Your ref: TR050007  
My ref: DCO/TR050007/HinckleySRFI

**TR050007 Hinckley SRFI– Warwickshire County Council (20040686/HRFI-AFP550 )  
Extension of Time - Comments on Documents Submitted by Applicant 10<sup>th</sup>  
December 2024**

Road Safety Audit Brief for Gibbet Hill junction (excludes page 1 as would require redacting of personal details)

### A426 northbound approach to Gibbet Hill junction – neutral weekday pm peak hour typical traffic speed data (INRIX Data & Google Maps)

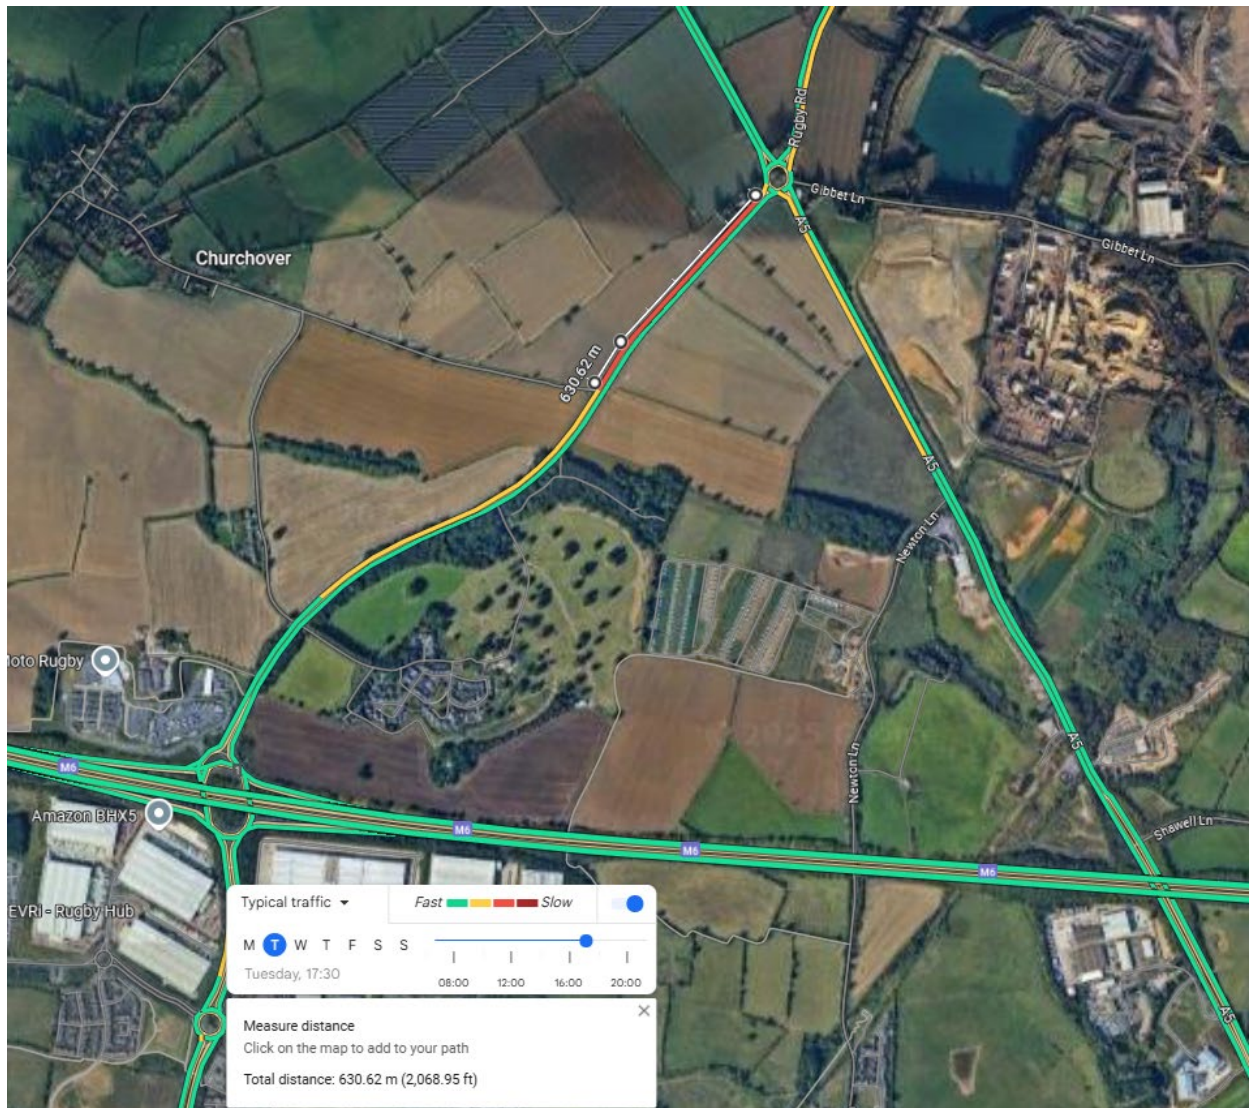
The ARCADY assessments submitted for the base year do not reflect the current peak hour queues observed on the A426 northbound, these indicate a queue of circa 300m in the pm peak hour, and the queue survey data recorded on behalf of the Applicant for reference purposes indicates queues in the order of 11 vehicles for most of the time slices recorded during the pm peak hour. This is not considered to provide a sufficiently accurate base model from which to assess impacts of the proposed HNRFI development or the proposed mitigation. Officers have observed queues on the A426 northbound of around 1-1.3km in the peak, average neutral weekday journey time data which is commercially available (INRIX Data) indicates an average journey speed of 18.9mph over the 2km link (from M6 junction 1 to Gibbet Hill junction) which has a

signed speed limit of 60mph, and typical traffic speed conditions available from Google Maps shows pm peak hour queues for neutral week days as ranging between 630-834m (Appendix B).

Figure 1: Location Plan

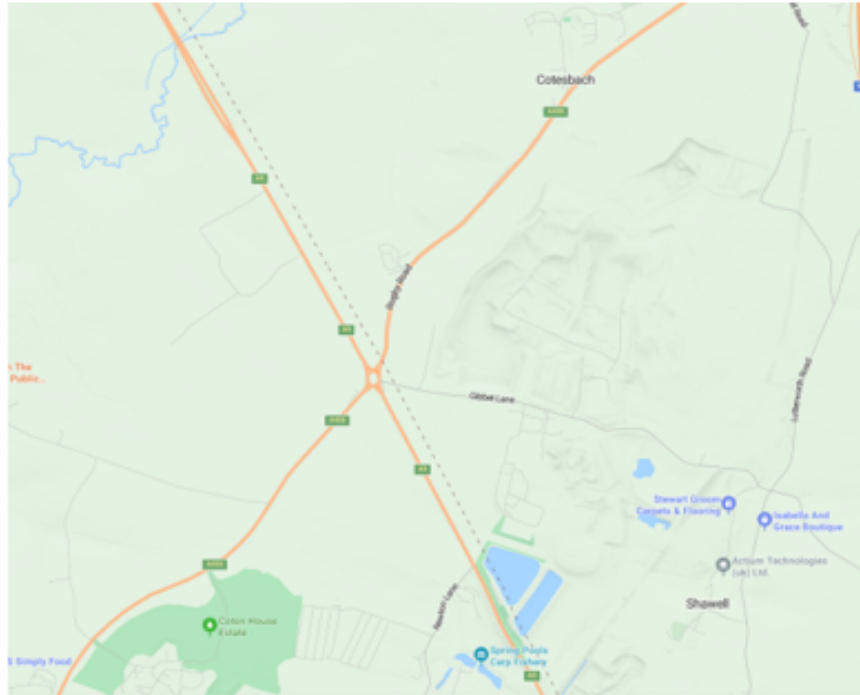
It is understood that the scheme proposed (HRF-BWB-GEN-XX-DR-TR-114 P3) to mitigate for the impacts of the proposed HNRFI development has not been agreed by National Highways. WCC has approved the appended Road Safety Audit Brief (Appendix C) for the proposed scheme, however if a different scheme is required/agreed with National Highways, then WCC would expect the Road Safety Audit process to be started afresh.

A concern raised by WCC with the proposed design is the swept path tracking. National Highways previously raised a concern over the likelihood either for two HGV's travelling side by side entering the junction and/or travelling around the circulatory carriageway for side swipe incidents to occur. If not addressed as part of the mitigation scheme WCC consider it is likely that HGV's will continue to position centrally on the approaches and on the circulatory to minimise this risk, therefore the mitigation scheme will not deliver the improvements intended. The revised scheme shows some minor kerb changes on the circulatory carriageway and some white lining on the circulatory carriageway. Whilst the swept path drawing referenced in the Road Safety Audit Brief (HRF-BWB-GEN-XX-DR-TR-134) shows the HGVs travelling side by side, the tracking speed used is 15kph (9.3mph), and some of the tracks have used a large number of target points to create the path which may indicate that a smooth and constant driving arc may not be possible in practice. BWB have advised that:

It is considered that HGVs will want to travel faster than 9mph around the circulatory of this reasonably large ICD roundabout, and if they cannot do so safely then they will continue to occupy central positions on the approach lanes and the circulatory. Notwithstanding the above assurance that the speed used is appropriate, if the DCO is consented, swept paths with speeds more commensurate with a large roundabout should be provided as part of the Road Safety Audit, as well as the tracking for semi – trailer HGV's, in order to be assured that an agreed mitigation scheme will be suitable and deliverable.

Other than the above parameters, the design speed to be used for swept path analysis is not stated in the DMRB. However, the swept path analysis was undertaken using the industry standard Autodesk Autotrack software. The software guidance recommends that manual amendments are made to limit turning radius where paths are tested faster than 15km/h due to dynamic effects on the vehicle which are not modelled by the software.

The guidance warns against testing above 15kph as adjustments should then be made to the dynamic effects (weight shift, tyre grip, roll over effect and a number of variables per vehicle). The guidance then goes onto warn: "The pre-defined dynamic values used in these dynamic settings are taken from AASHTO and TAC handbooks are intended for use with normal road vehicles, i.e. cars, lorries etc. If your vehicle is very large, e.g an aircraft or very small then they may not be appropriate, or you may need to define custom values".

Vehicle tracking is a constant speed analysis whereas in reality, vehicles will slow down at the entry to the roundabout and then speed up again at the exit. Adjusting the speed variable only effects the steering input applied over a certain distance as steering is applied at a fixed, constant rate. Therefore, at higher speeds, vehicles travel further while steering angle is being applied. The vehicle speed setting does not affect the amount of space required for a vehicle to undertake a given manoeuvre.

Therefore, the speed used in the swept path analysis is appropriate and altering this speed would have negligible effect on the design.
